City Planning Commission Meeting
Tuesday, May 26, 2015

PRELIMINARY STAFF REPORT

To: City Planning Commission
Design Review: 042/15

Request: This request is an appeal of the Eastern New Orleans Urban Corridor (UC) District regulations, **Article 10, Section 10.1B.9.1- Permitted Detached Identification Signs** of the *Comprehensive Zoning Ordinance*, to permit a detached pole sign with excessive sign area, excessive height, insufficient setback from the adjacent public right-of-way, and insufficient landscaping.

Figure 2: Remaining base of former sign

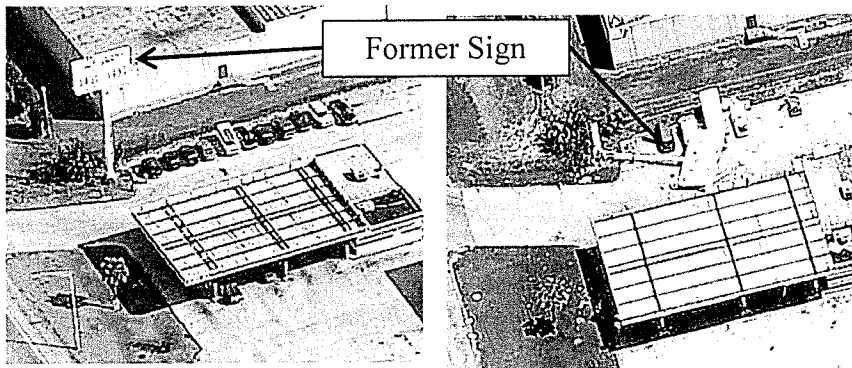
proposing to install a new sign in the existing base of the former sign. The Zoning Administrator has determined that the remaining sign base does not qualify as a non-conforming sign, and thus should be treated as a new sign.

Figure 3: Proposed Sign Dimensions

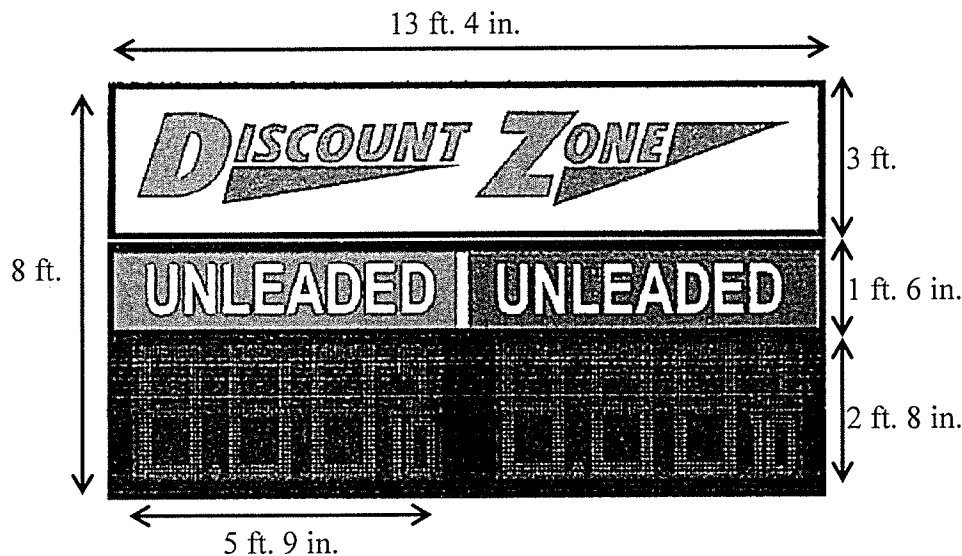
The permitted sign area in the Eastern New Orleans UC District is calculated based on lineal street frontage. The district allows one square foot per lineal foot of street frontage with a maximum of 70 square feet. The subject site has 300 feet of frontage along Chef Menteur Highway, and thus is permitted the maximum sign area of 70 feet. The proposed sign measures 13 feet, four inches in width, eight feet in height, for a total sign area of 106 square feet. The proposed sign exceeds the permitted sign area, therefore a waiver of **Article 10, Section 10.1B.9.b - Permitted Sign Face Area** is required.

Detached signs in the Eastern New Orleans UC District are permitted to have a message area or menu board, provided that the changeable message area is not greater than 30% of the sign area. The proposed sign has two digital screens that will be used to display gas prices. Each screen measures two feet, eight inches in width and five feet, nine inches in height. The area of each screen is 15.33 square feet, for a total combined area of 30.67 square feet. The total area of changeable message area for the proposed sign is 28.75%, which complies with the 30% limit.

The maximum height of detached signs is limited to 12 feet. The proposed sign's height is 30 feet, far exceeding this requirement. Thus a waiver of **Article 10, Section 10.1B.9.1(d) - Permitted Height** is required.

The Eastern New Orleans UC District requires that detached signs be setback from all adjacent public rights-of-way a distance equal to the height of the sign. This setback is to be measured from the nearest portion of the sign. The proposed sign height is 30 feet, thus the proposed sign would be required to be setback 30 feet from the public right-of-way. At the time of application, the applicant provided a survey showing the location of the sign, however it did not expressly state the distance from the sign to the right-of-way. The staff requested the measurement from the applicant several times, however the applicant has not responded. Using Bluebeam Revu software, the staff approximated the distance from the right-of-way to be 10 feet, seven inches. This distance is less than the proposed height of the sign, so it does not comply with the setback requirement of the District and thus a waiver of **Article 10, Section 10.1B.9.1(e) - Permitted Location** is required.
